CITY OF ALBUQUERQUE

August 12, 2022

RE: Office / Warehouse
541 Airport Dr NW
Grading & Drainage Plans
Engineer's Stamp Date: 06/22/22
Hydrology File: K10D023K

Based upon the information provided in your submittal received 08/04/2022, the Grading & Drainage Plans **are not** approved for Building Permit. The following comments need to be addressed for approval of the above referenced project:

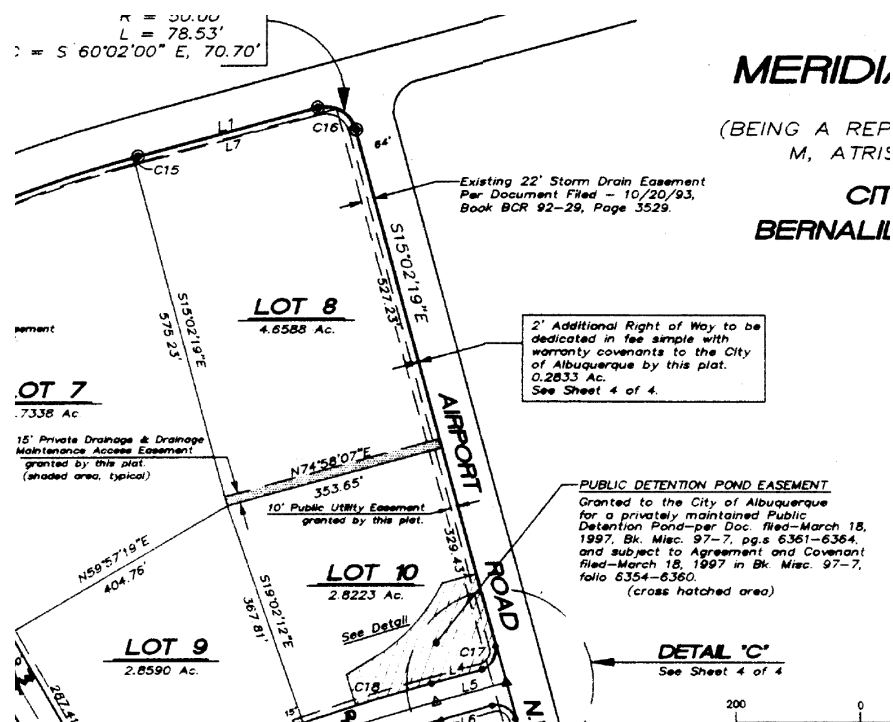
1. Please show and label all existing easements that are shown on the recorded plat. (see attachment)

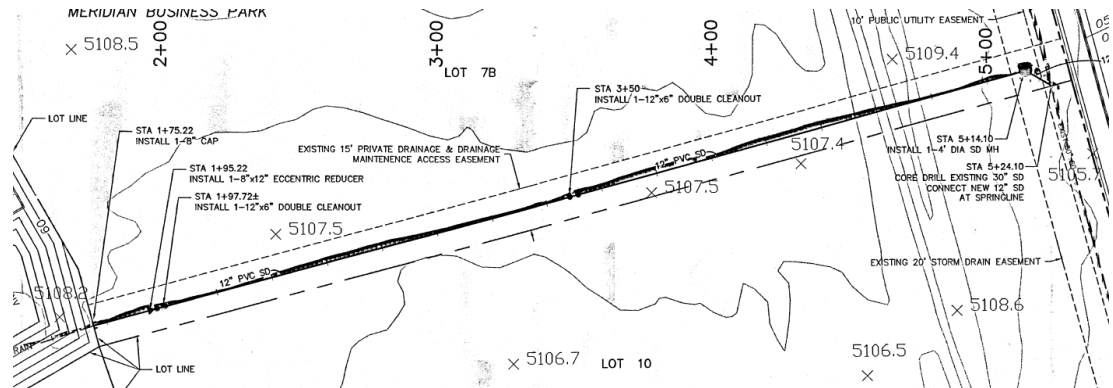
- Please show and label the existing 12-in PVC storm pipe within the existing 15' Private drainage easement. (see attachment)

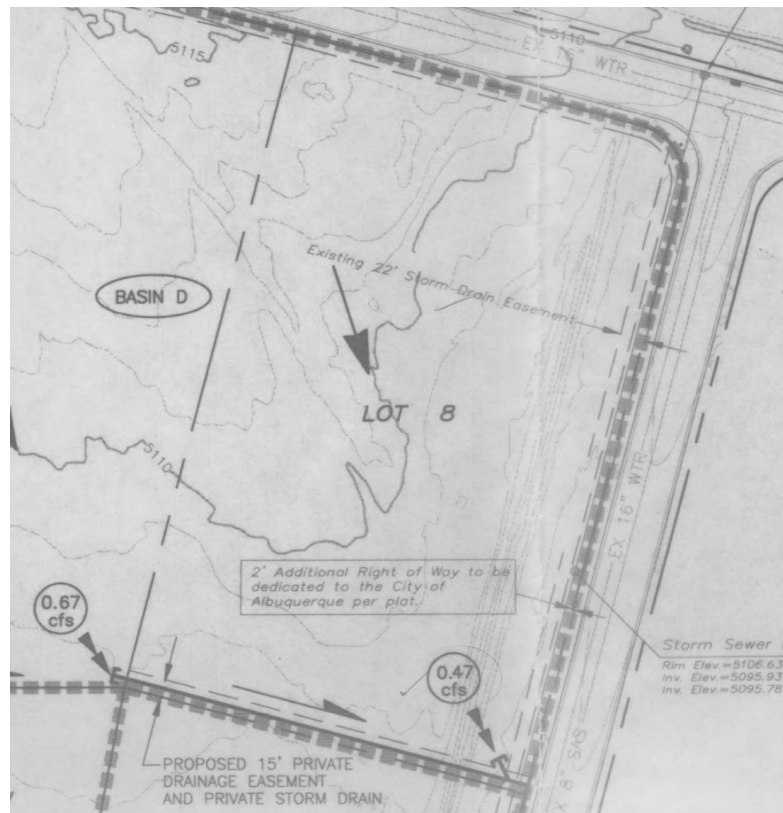
- Please follow the current Meridian Business Park DMP. Only Lot 10 can drain to the Public Detention Pond at the southeast corner of Lot 10. Lot 8 has to have its own detention pond with the allowable rate of **0.47 cfs**. This pond will then discharge into the existing 12" PVC within the existing private drainage easement.

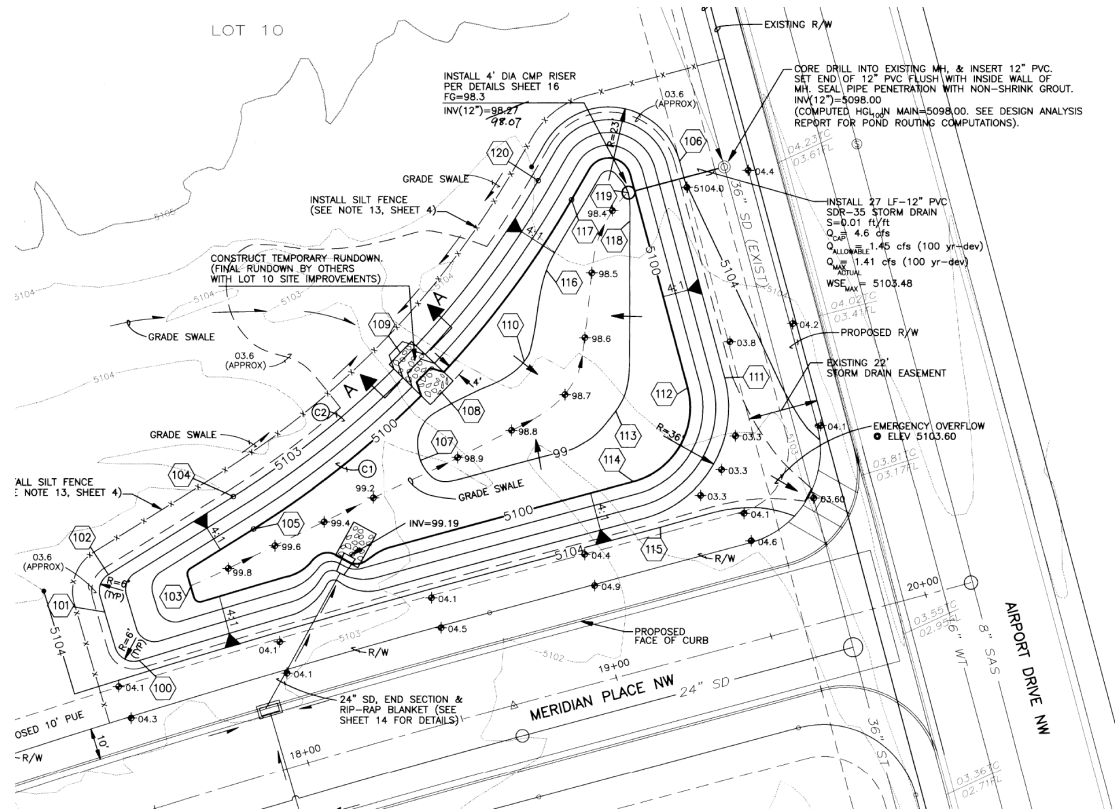
5. As for the existing detention pond, it is in bad shape and needs to be re-established which looks like you were planning. Please note that the original pond design currently violates the current DPM. The pond needs a valid spillway which cannot use the ADA ramp and the pond needs one foot of freeboard from the water surface 100 yr detention elevation and the top of the pond. Also, the existing 24-in inlet pipe on Meridian Place needs to be re-established since it appears to be partially filled in with dirt. Finally, please inspect the existing outfall structure for the pond. If this needs to be replaced during the pond re-construction than please do so. Below is the original design of the pond when it was built back in 1998.
